Addendum No. 04

The Construction of Crosby Sixth Grade Campus

Crosby ISD RFP# CSP 2526-0002

Addendum Number Four (04)
TO PLANS AND SPECIFICATIONS for
Crosby Sixth Grade Campus For Crosby ISD
STANTEC Project No. 214001329

A6 / G510 ARCHITECTURAL SITE PLAN

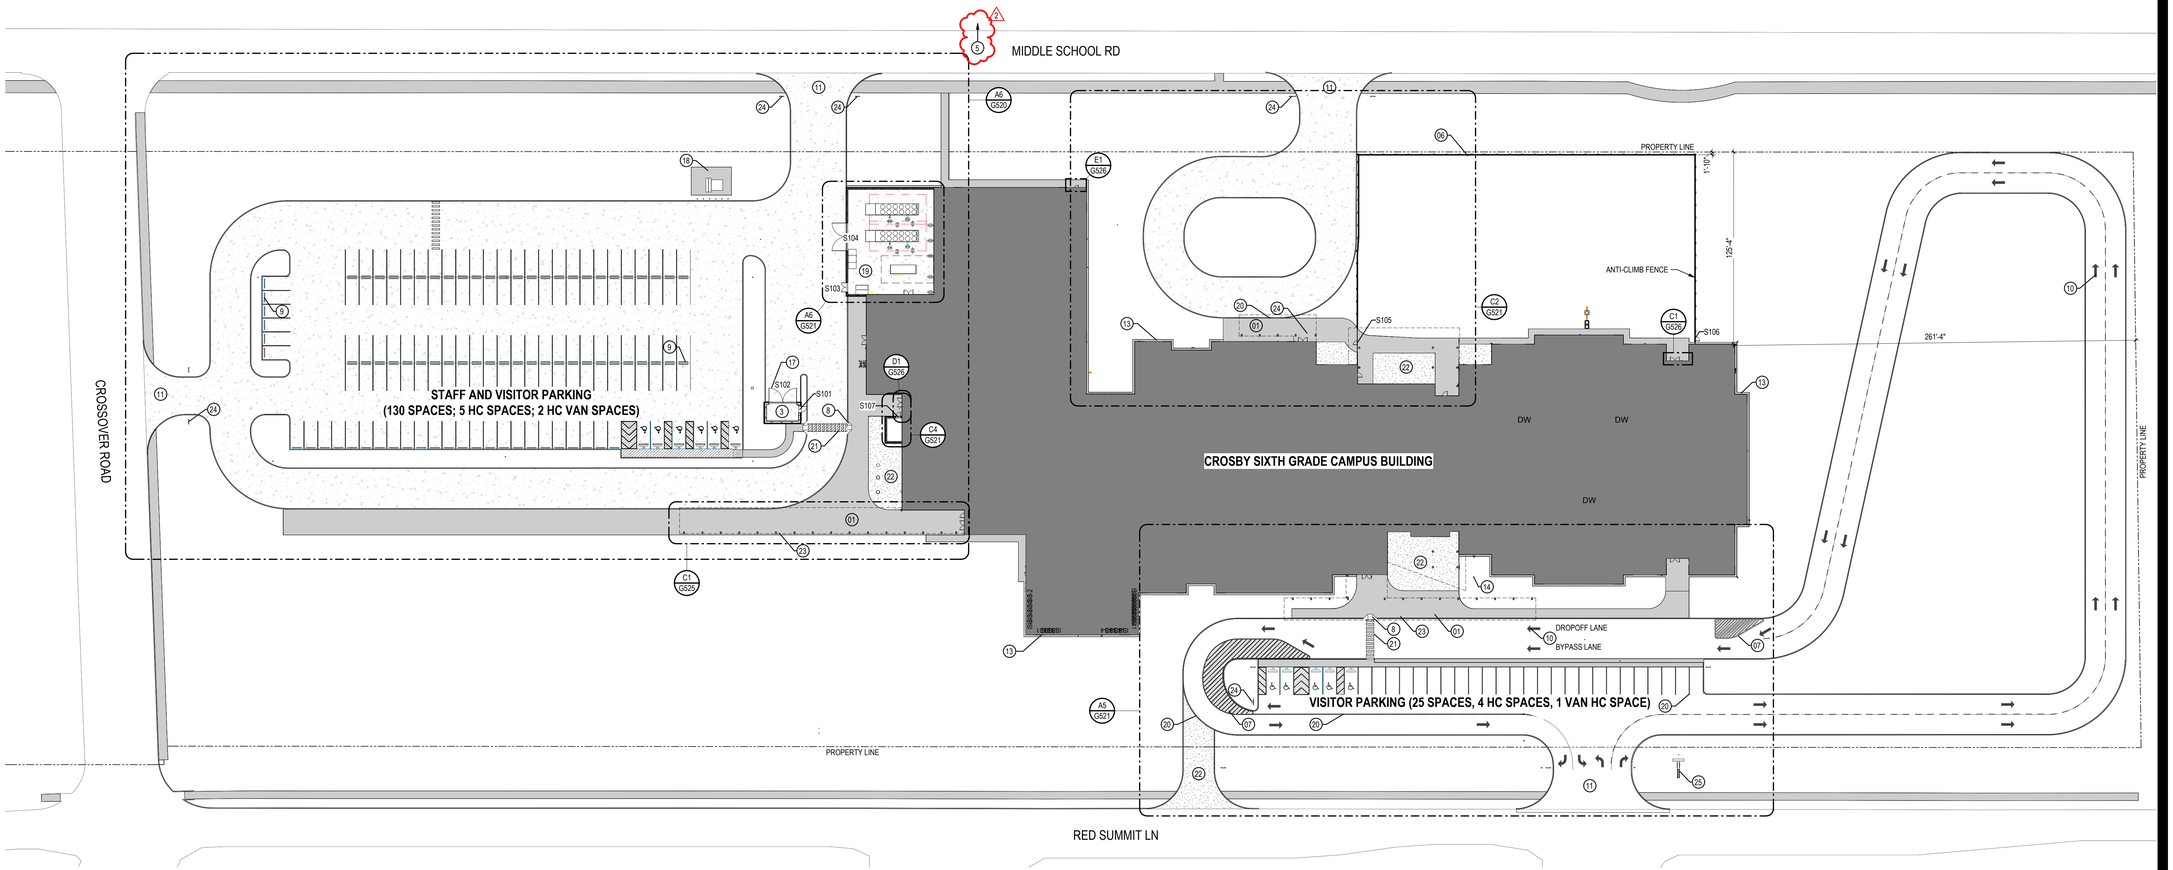
Q: Per review of Sheet G510, the fence detail appears to indicate installation on a 6-inch curb. Please confirm that the design intent is for the fence to be installed directly on a 6" concrete curb as shown.

Q: On the gate schedule it states the gate to be a chain link fence but on page G523 detail A6 it calls for metal panel, please clarify on which we should provide.

R: Addendum #4 will include Door Hardware Specification update for Gate hardware sets. Sheet G510 will be updated to reflect hardware sets.

1. Sheet G011:
   - **Added** Missing sheets added to Index**.**
2. Sheet G510:
   - **Updated** Note 5 added to indicate general direction of chain link fencing at off-site detention pond.

- **Revised** note clarifying location of chain link fence.
   - **Revised** to add gate hardware set numbers.
3. Sheet G520:
   - **Updated** Detail callout B4/A062 included on A3/A342.

C4 G521 ENLARGED PLAN - SITE WALLS

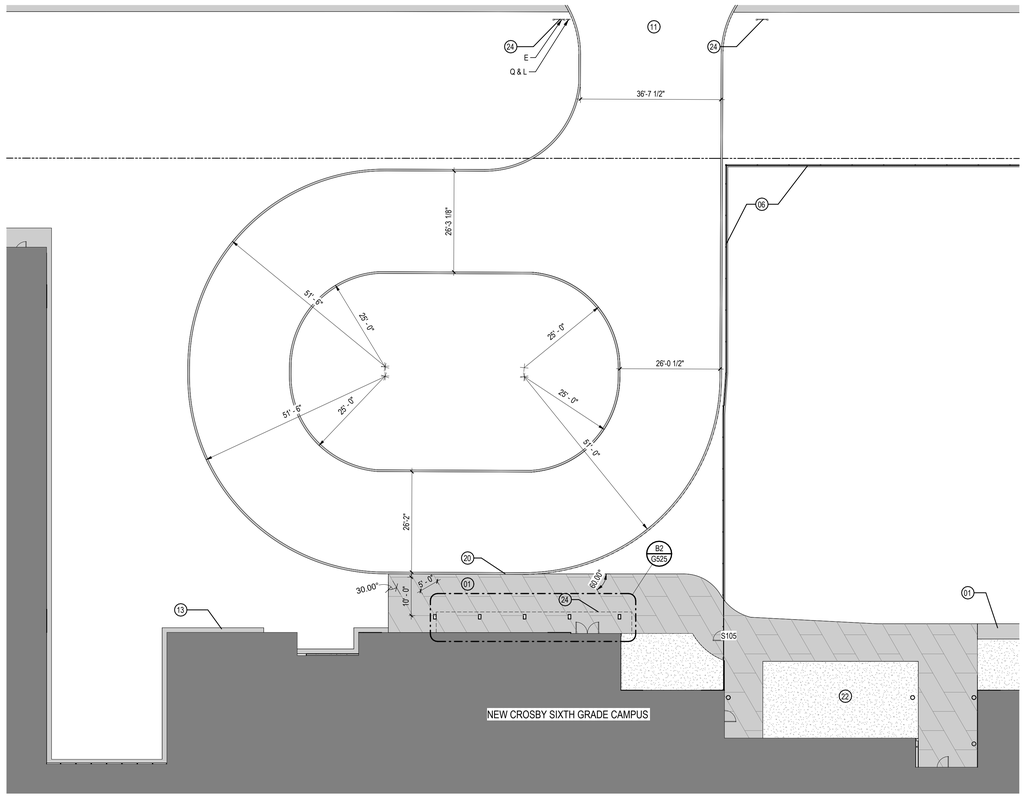
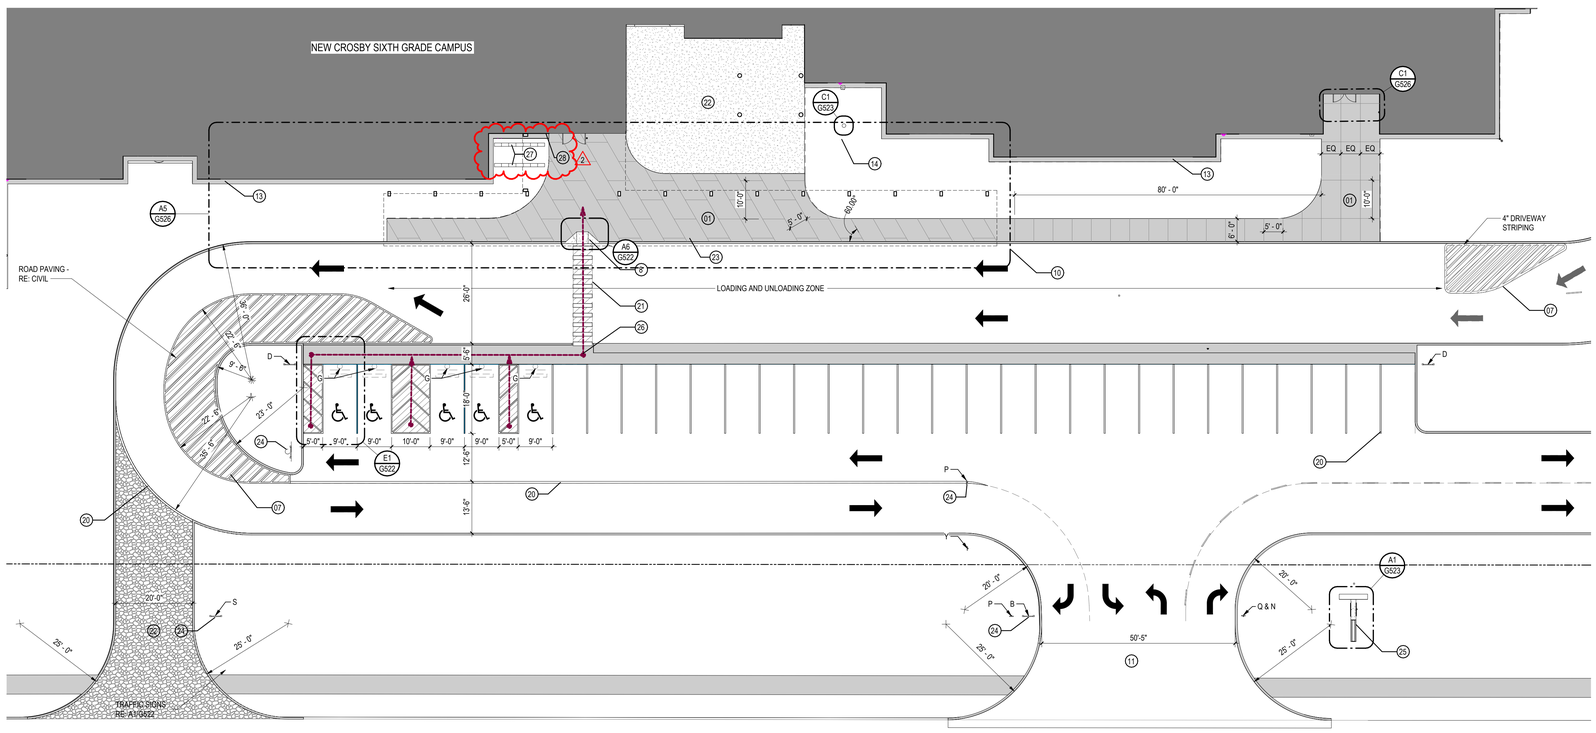
4. Sheet G521:
   - **Updated** to add bike rack locations.
5. Sheet G523:
   - **Updated** to clarify chain link screen on rolling gate.
6. Sheet G525:
   - **Updated** Soffit panel call out at walkway covers. Ref: RFI note 44

A6 A113B
ROOF PLAN - AREA B
1/8" = 1'-0"

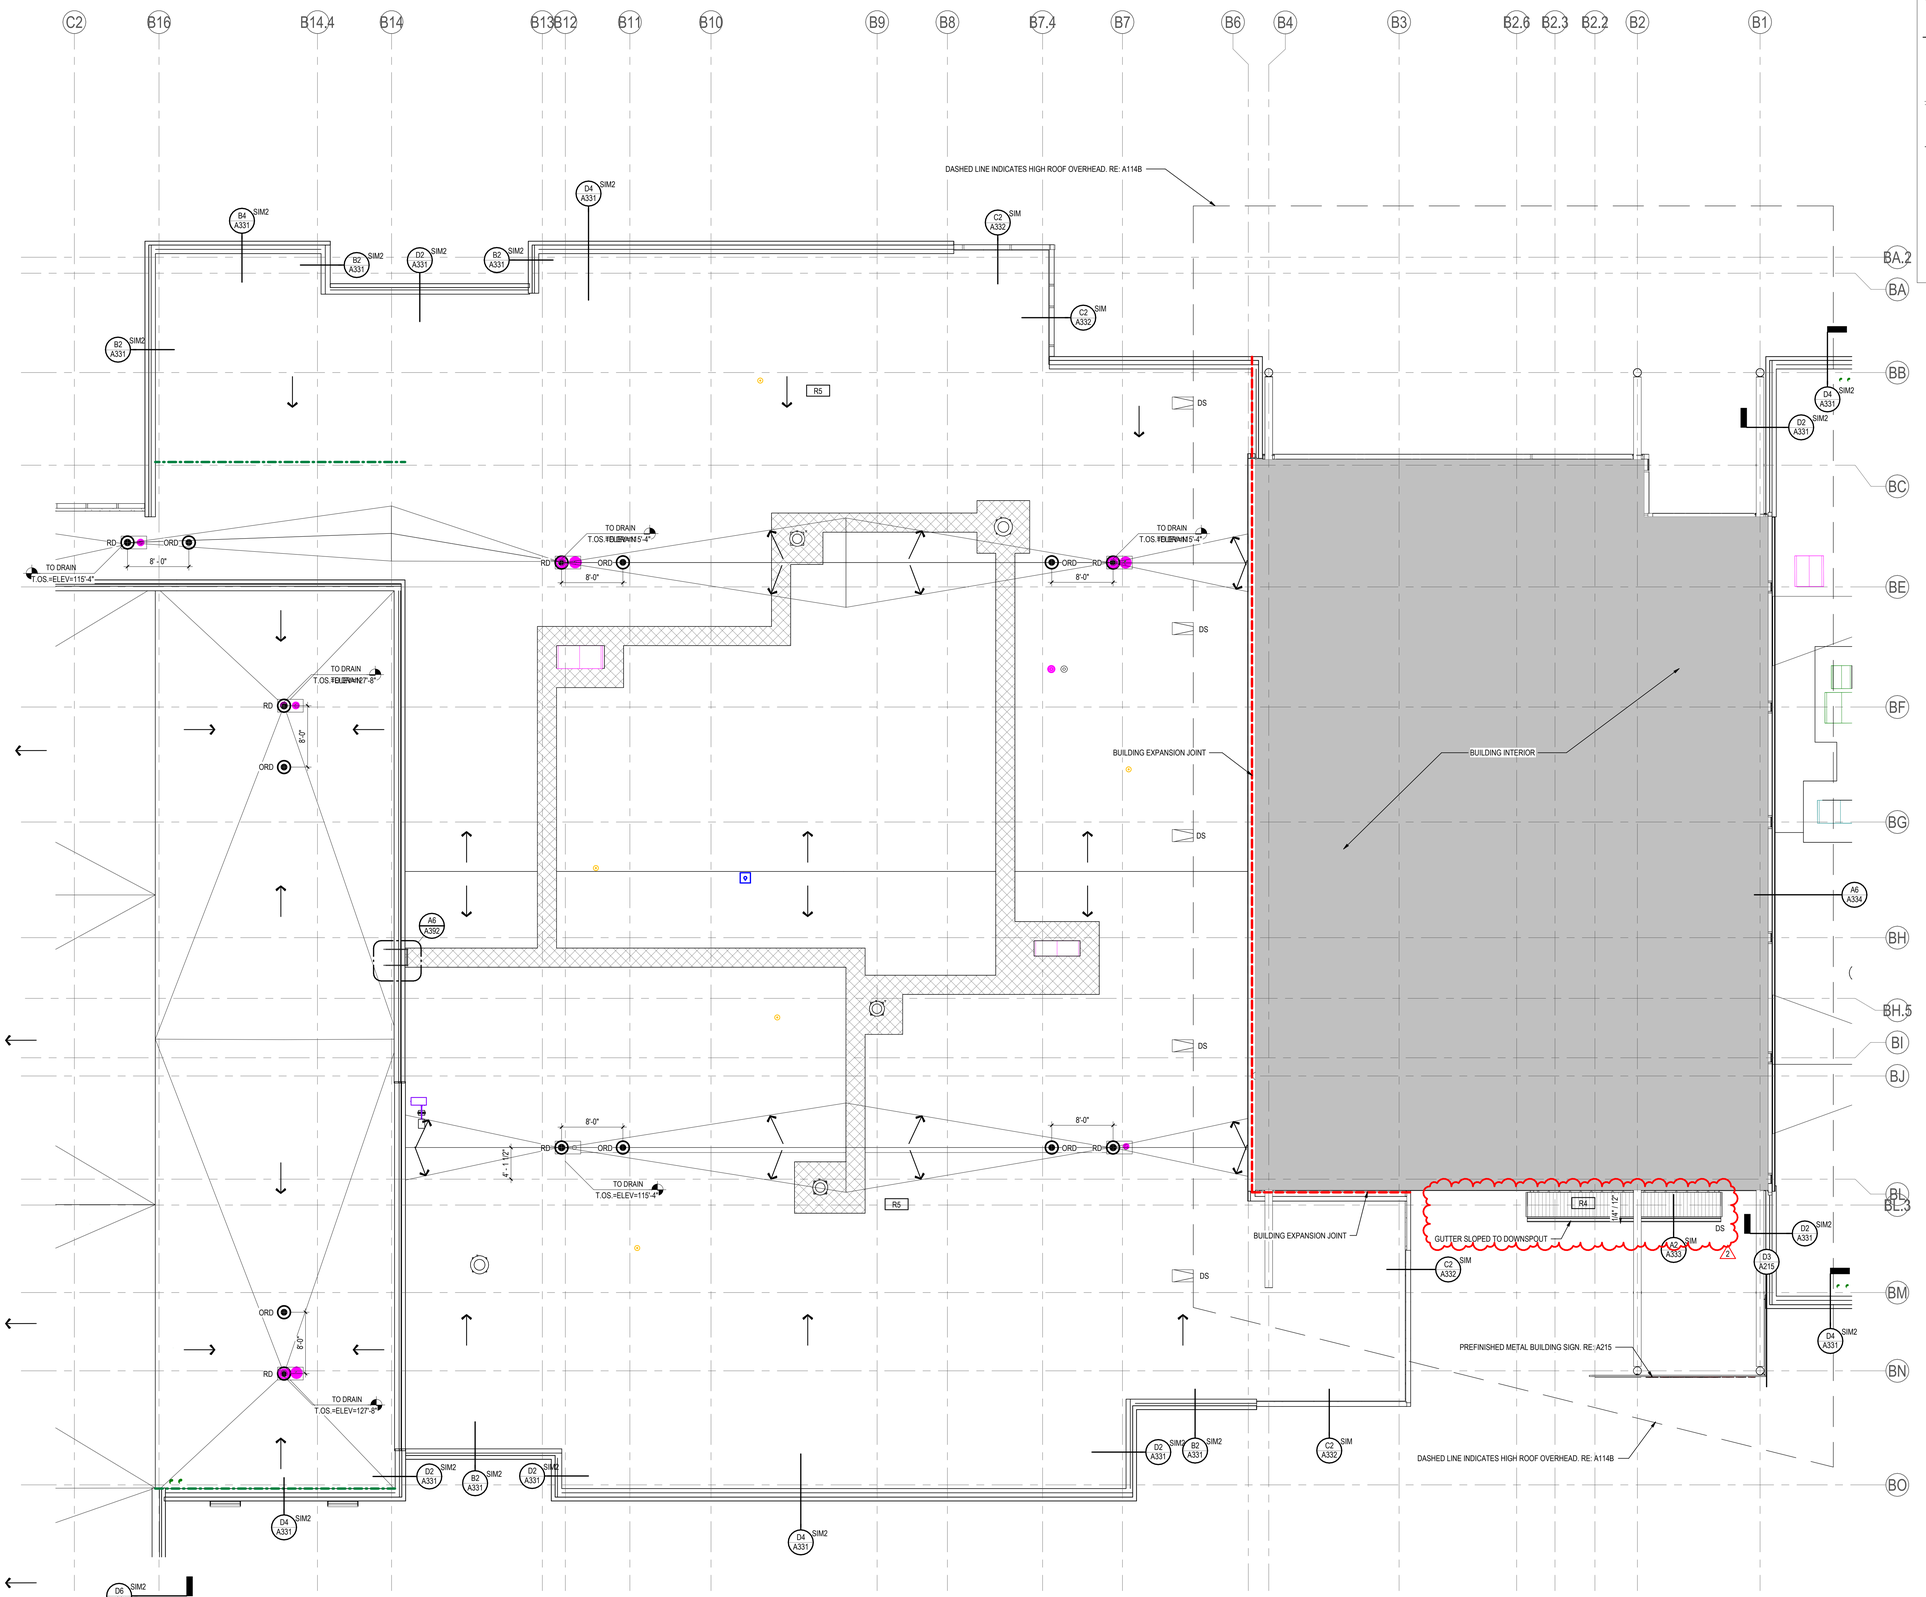
11. Sheet A112C:
    - **Updated** Shifted wall and clerestory window to be face of metal panel at 1'-6" off Grid C7.
12. Sheet A113B:
    - **Clarification** of small R4 roof in Area B.

A6 / A123A — **ENLARGED CEILING PLAN - MEDIA CENTER CLOUDS**

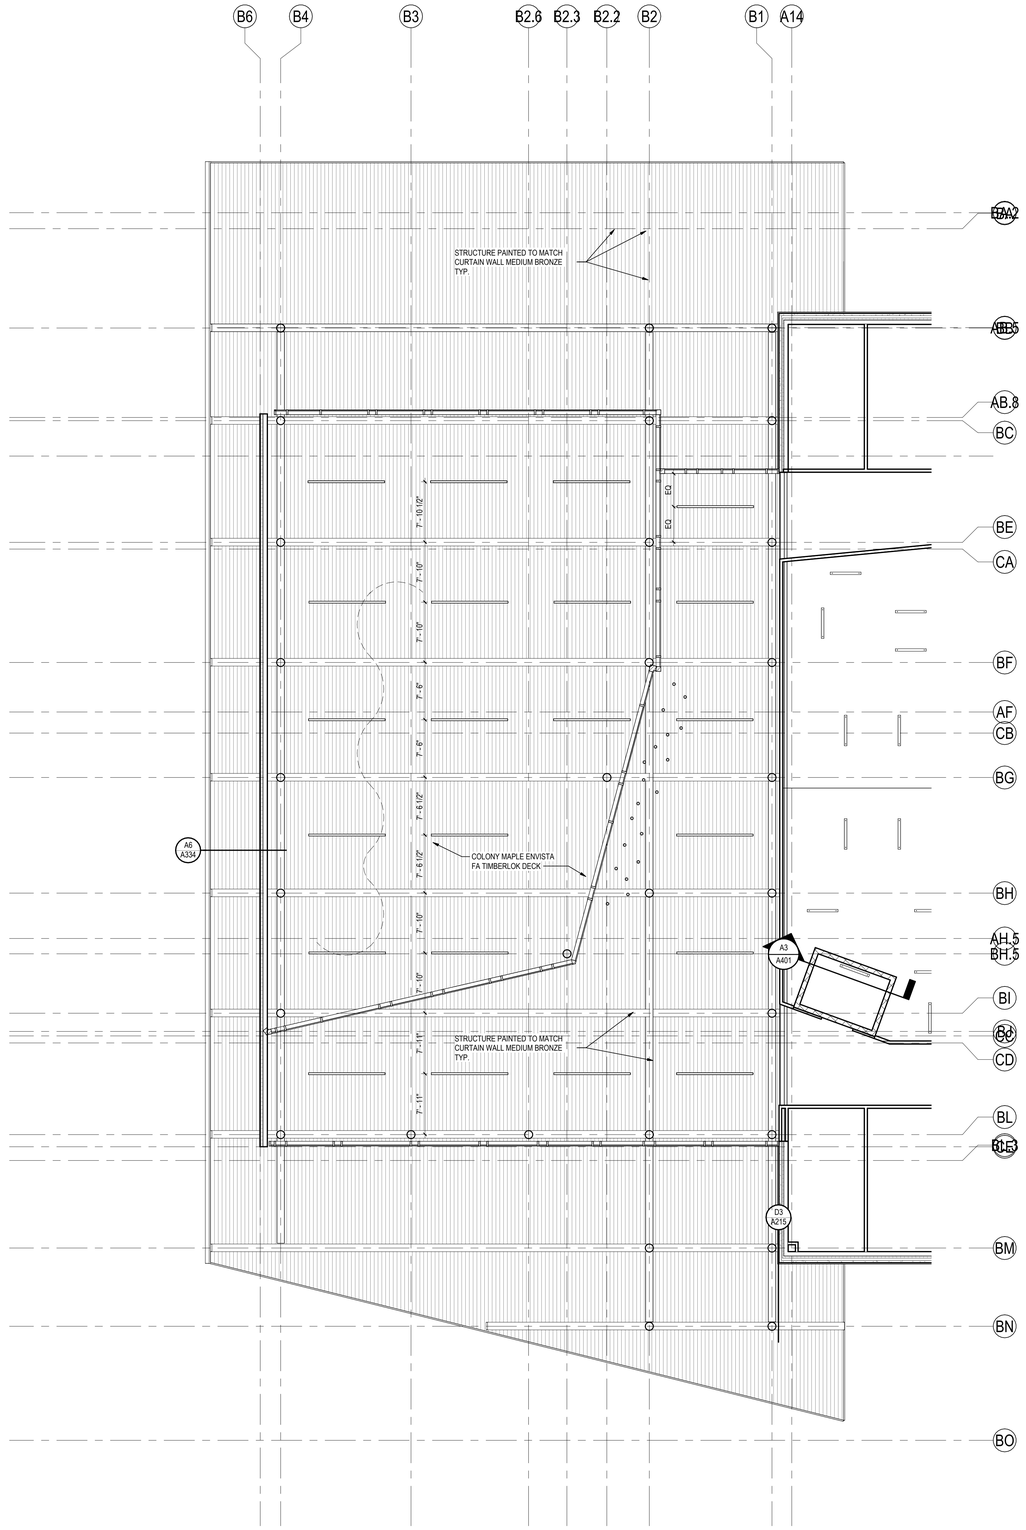
- **Updated** Light fixtures line weights.
18. Sheet A123A:
    - **Added** Enlarged plan for information.
19. Sheet A141:
    - **Added** Instrument storage legend.

A6 A141 **FURNITURE PLAN - LEVEL 1 - OVERALL**

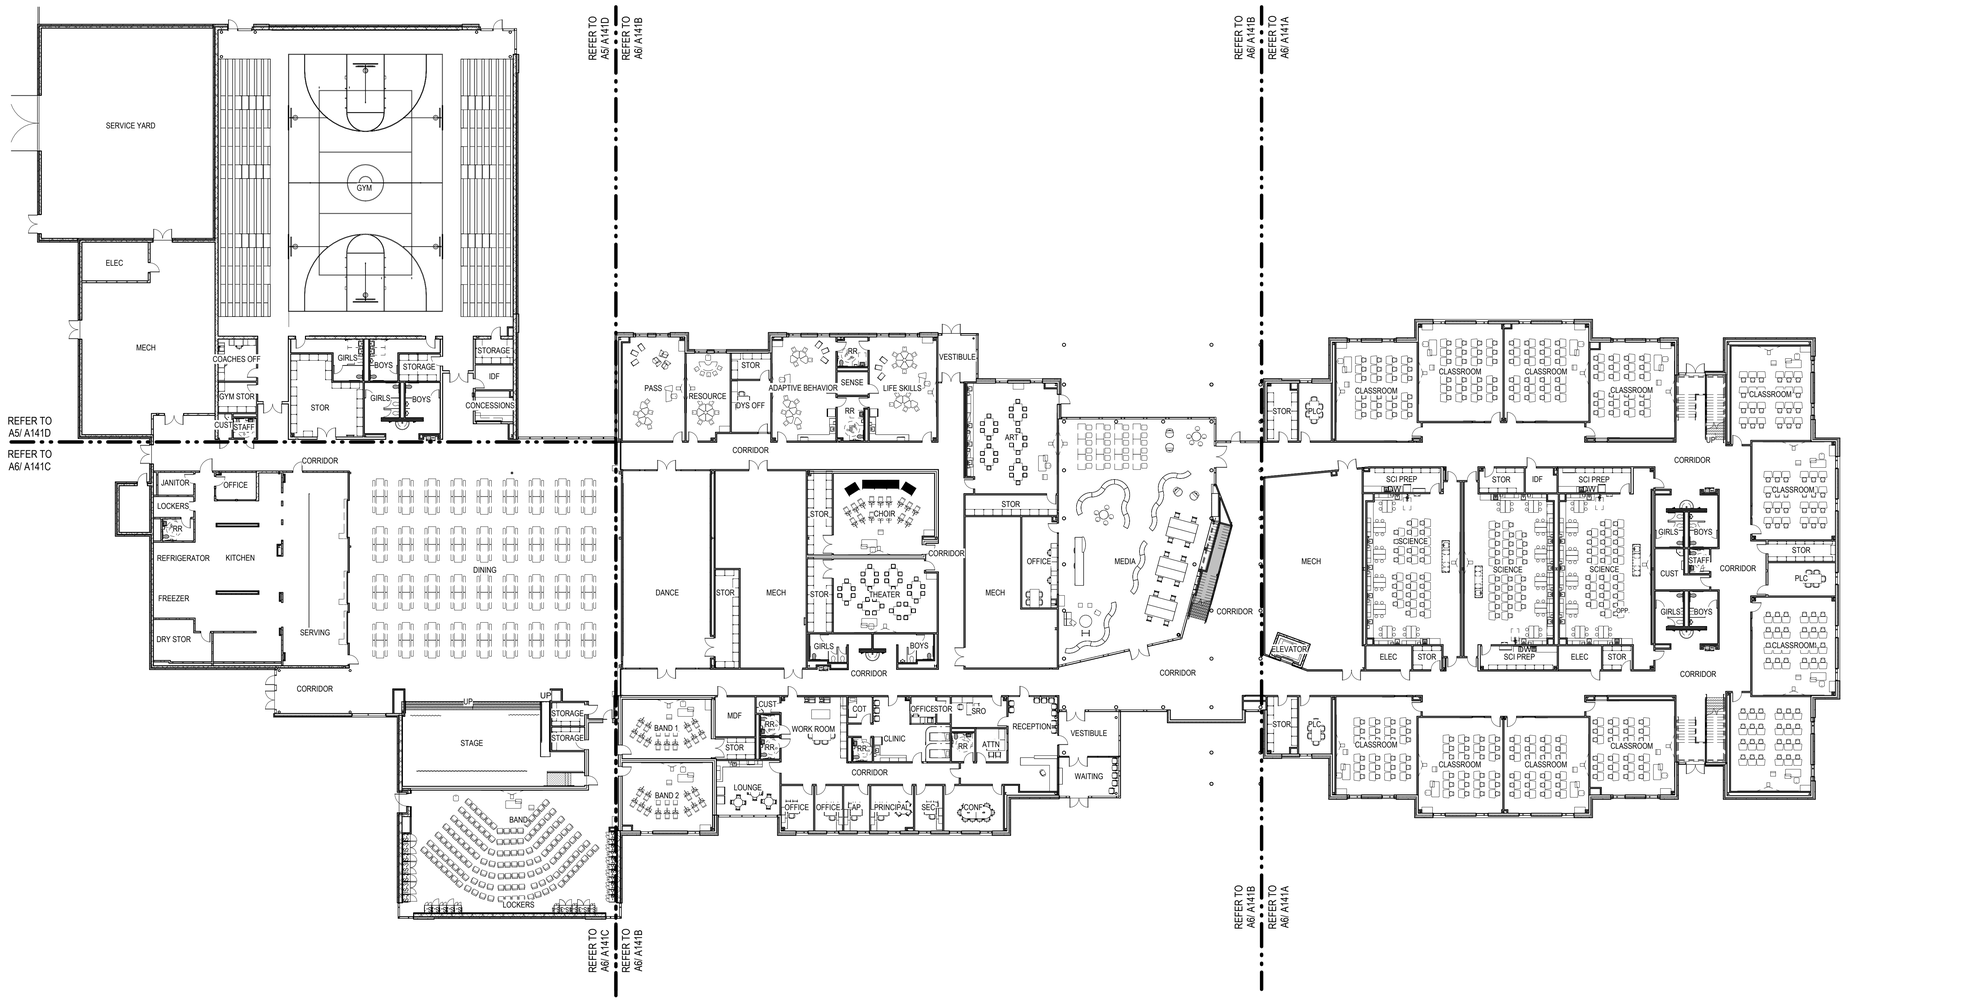
Q: Can you provide details for MS1, MS2 and MS3 metal shelving units?

R: Please refer to Sheet A141 in Addendum 01 for clarification on MS1, MS2, and MS3 detail and table.
